ADDENDUM NO.: THREE DATE: 29 July 2013

PROJECT TITLE: HORIZON GROUND AND FOURTH FLOOR UPFIT

University of South Carolina State Project No. H27-6081-AC WTS Project No. 11700/ File 7.0

ADDENDUM NO.: TWO DATE: 25 July 2013

Ground Floor Panelboard Schedules

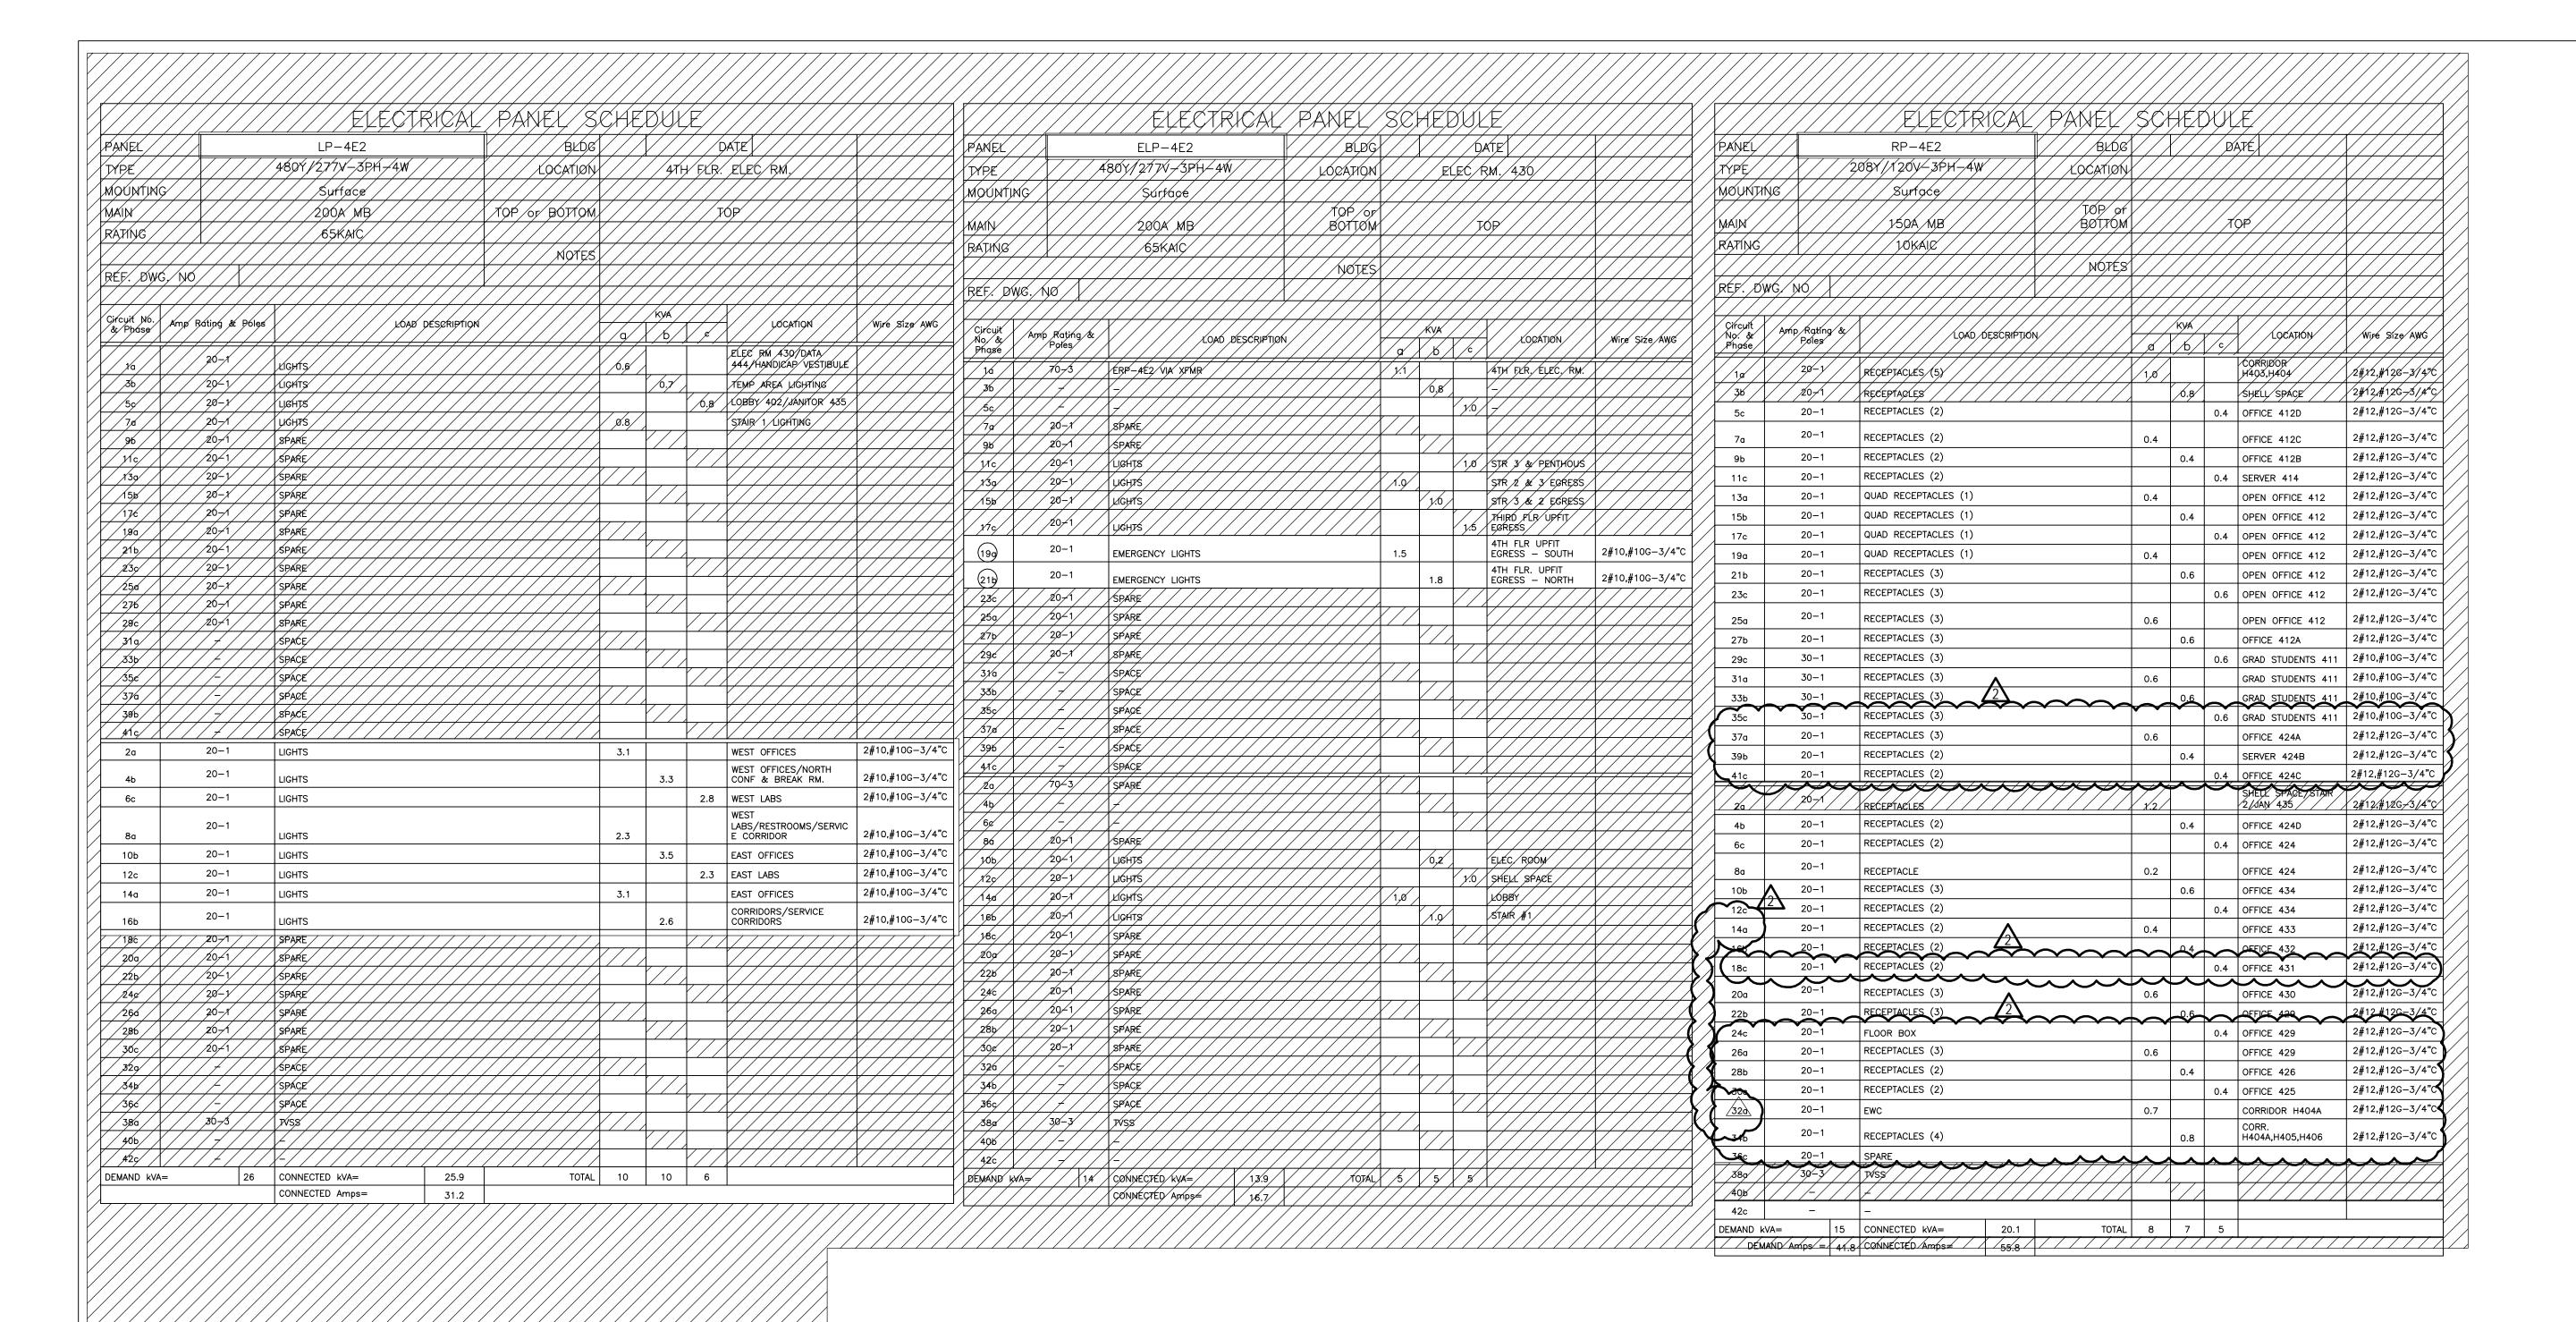
1. Add keynote 1 for panel ERP-0D2, ERP-1E2, ERP-2E2, ERP-3E2, and ERP-4E2. Replace this drawing with drawing EP5.61 in this addendum.

4TH FLOOR TELECOMMUNICATIONS ROOM 1

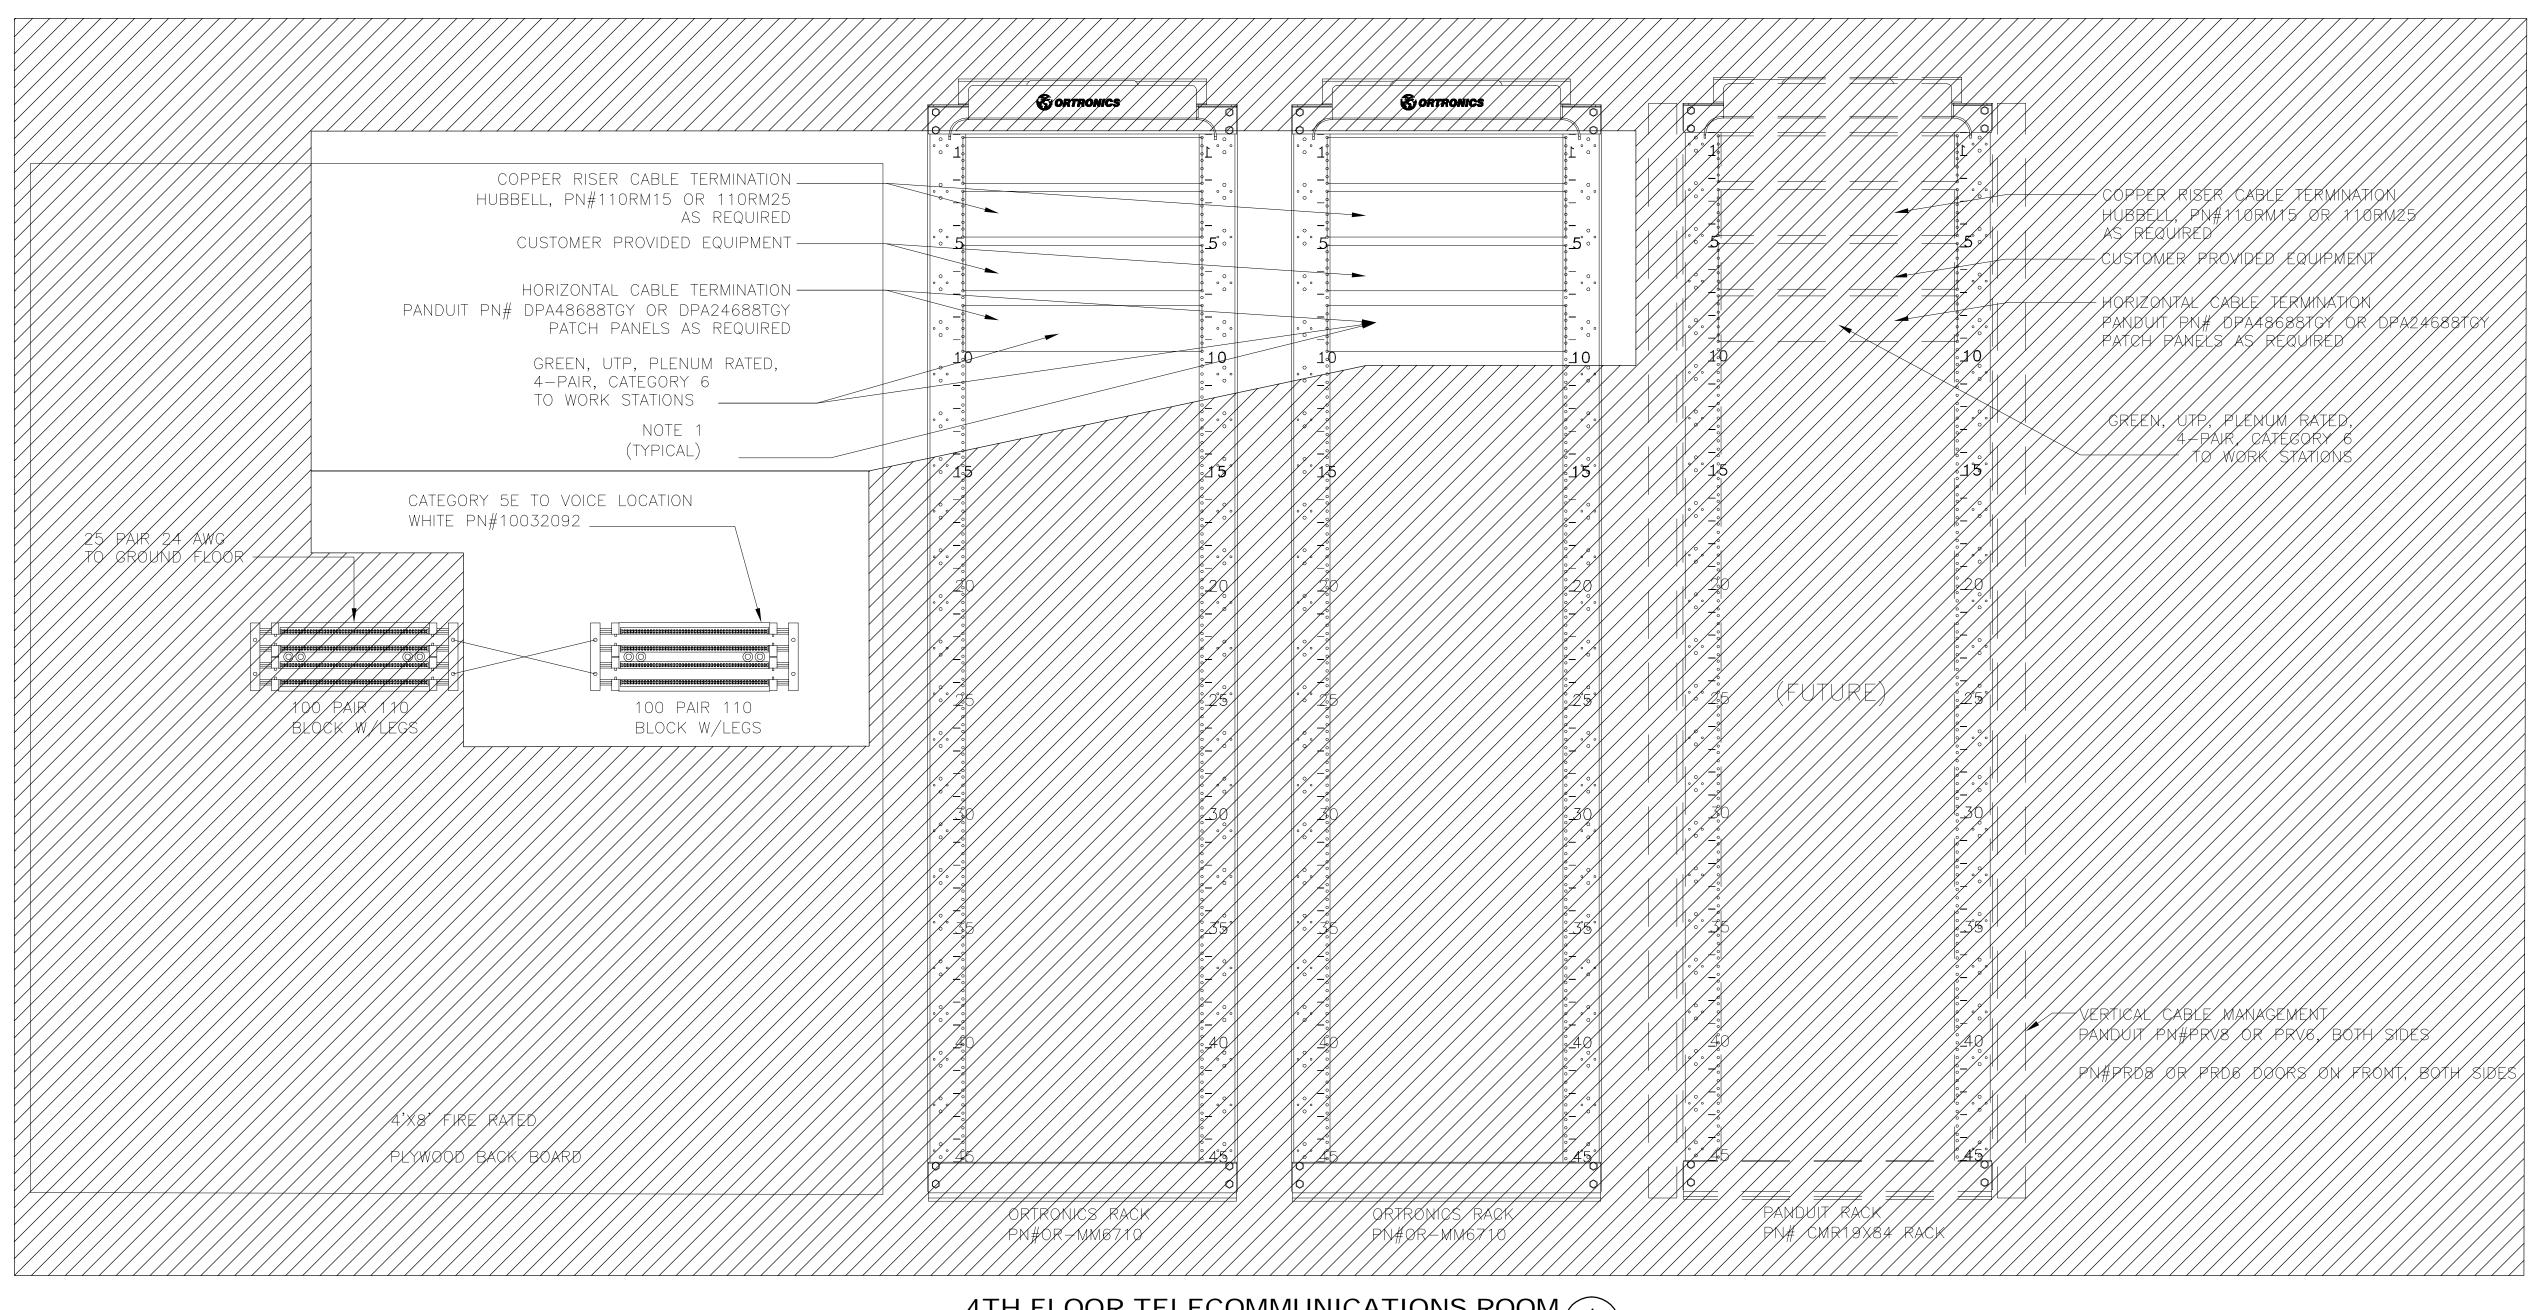
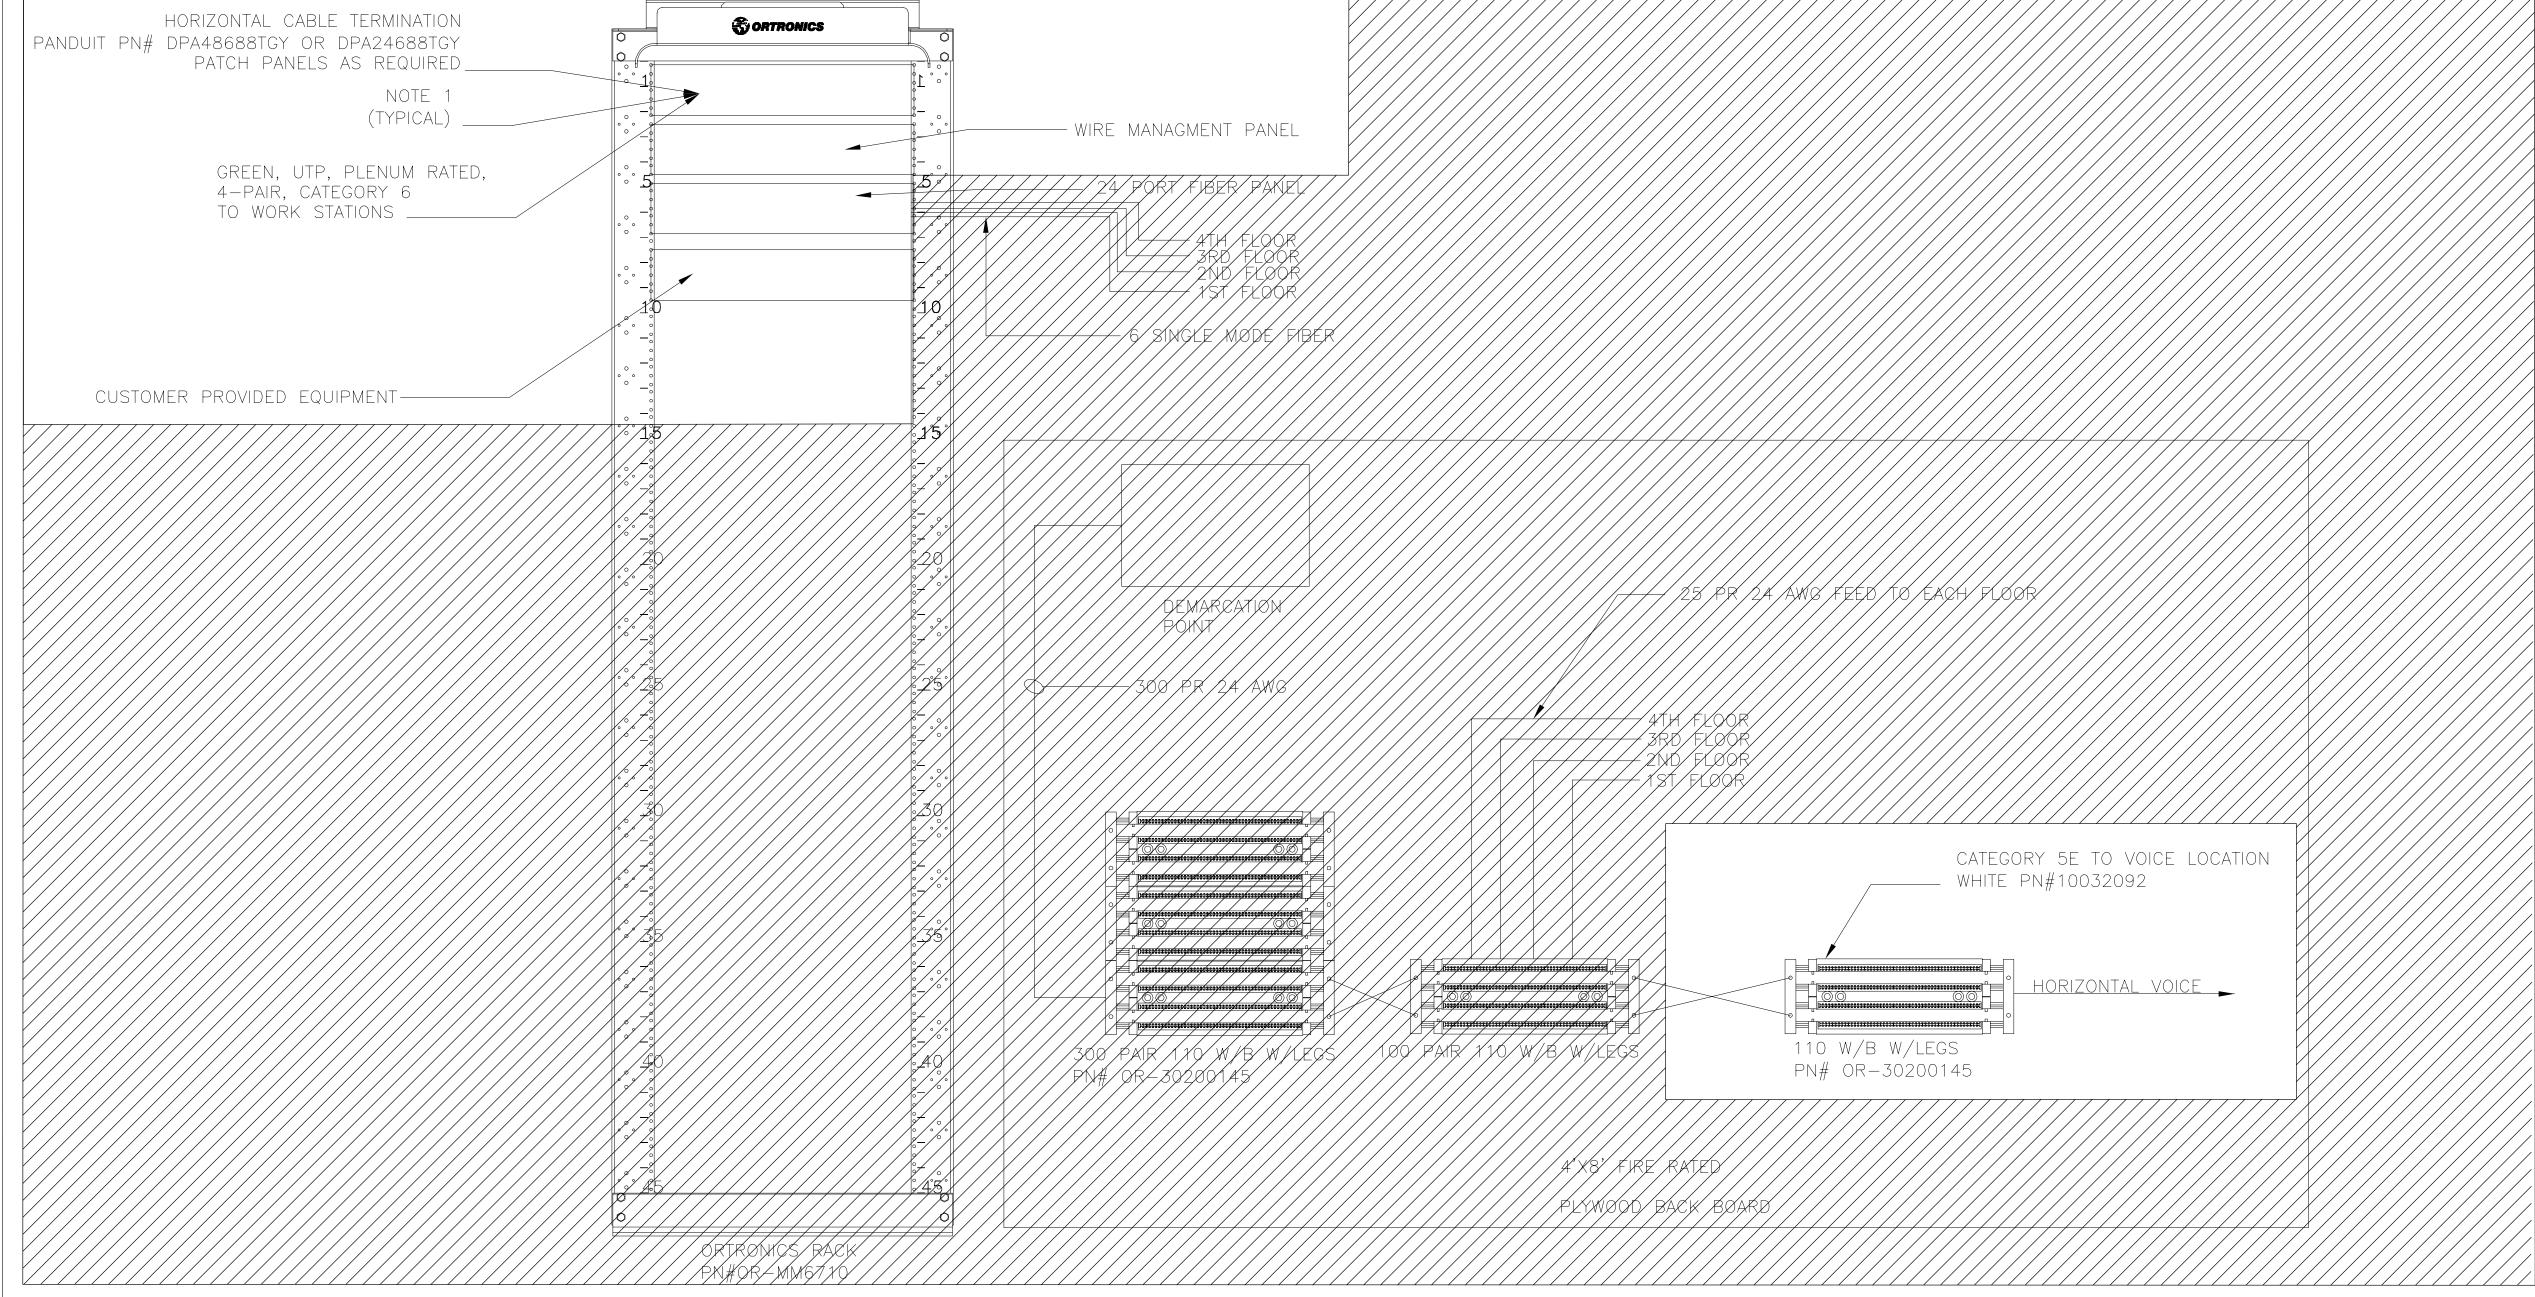
1. Revise note G, General Contractor. to provide fire-stopping. Replace this drawing with drawing ET3.01 in this addendum.

2. The electrical drawing indicate that the fire stopping is to be by the general contractor except on the addendum #1 sheet ET3.01 where it states it is by the electrical contractor. The mechanical drawings do not seem to indicate that the fire stopping is to be by the general contractor. The electrical contractor is the only one that can tell how many penetration that will be required for their work as the routing of the piping isn't indicated on their drawings and each different electrical contractor is subject to run their work in a different manner that effects the amount of penetrations. As it is normal for the trades to include fire stopping for there penetrations, please remove the note indicating that it is to be by the general contractor.

Response: Firestopping is required to be by General Contractor. See updated sheet ET3.01
